Building Location Plat

Lot 17 Block D  
LINDEN CHAPEL HILLS  
Section 4  
Howard County, Maryland

WALK-THRU BUILDING PERMIT  
BP# B00153101 A# 500034  
APP. SAN KJR DATE: 4/13/05  
DESC. OF WORK: Bed, Bath, Sub. Com.  
17

Building Location Plat

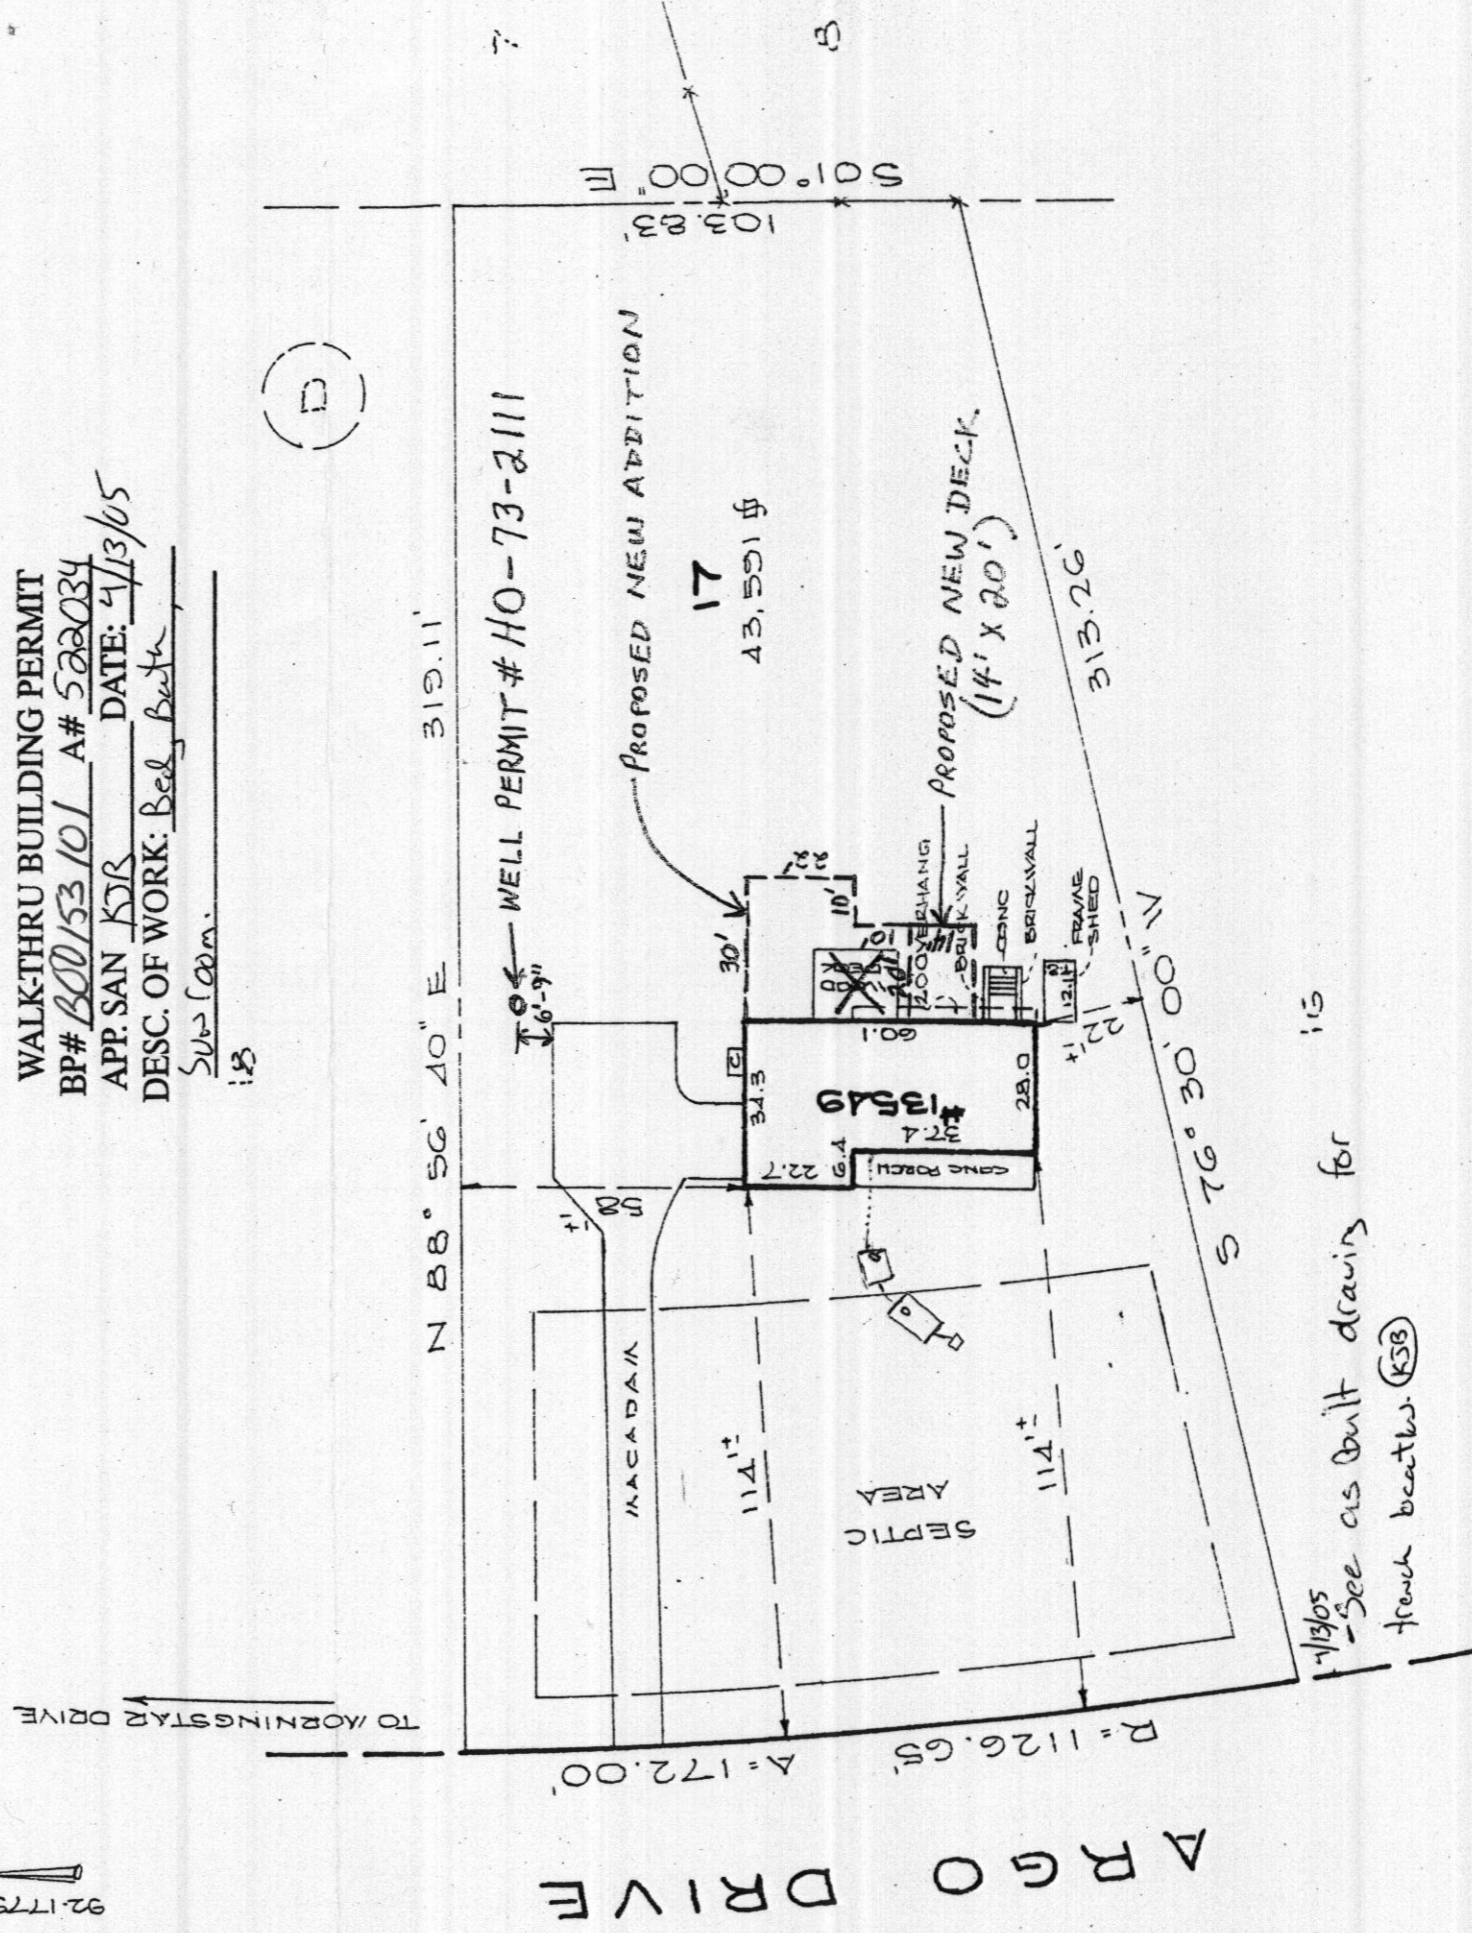
4/13/05  
- See as built drawings for trench breaks. (KSB)

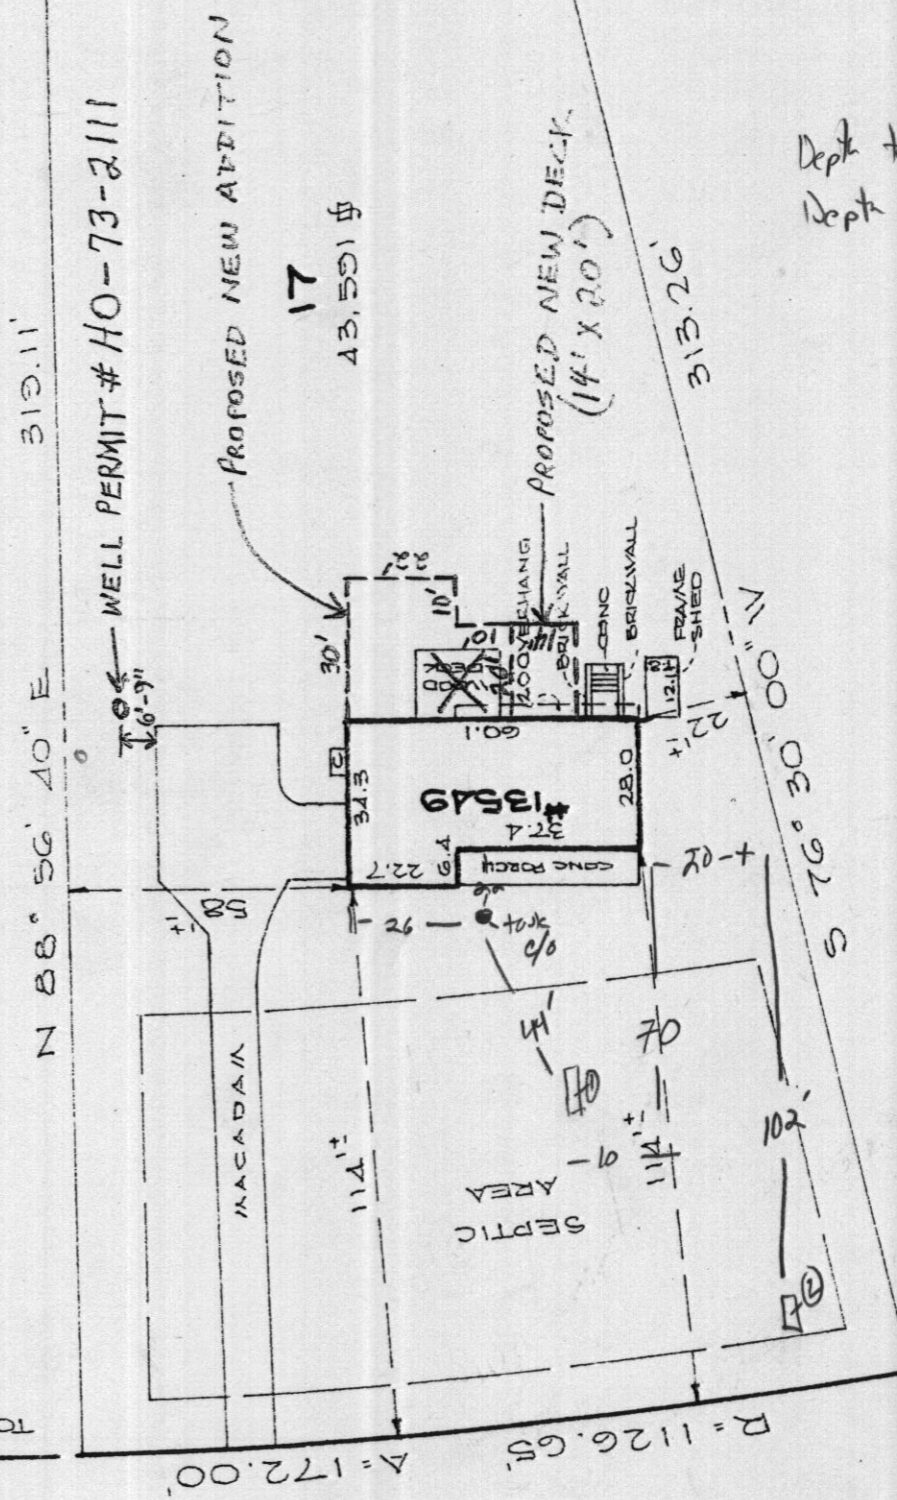
Permit denied @ this time. Total # bedrooms proposed = 5. Age of system needs inspection; current system not adequate for five bedrooms. Need at least 1500 gallon septic tank & additional trench based on perc rate.
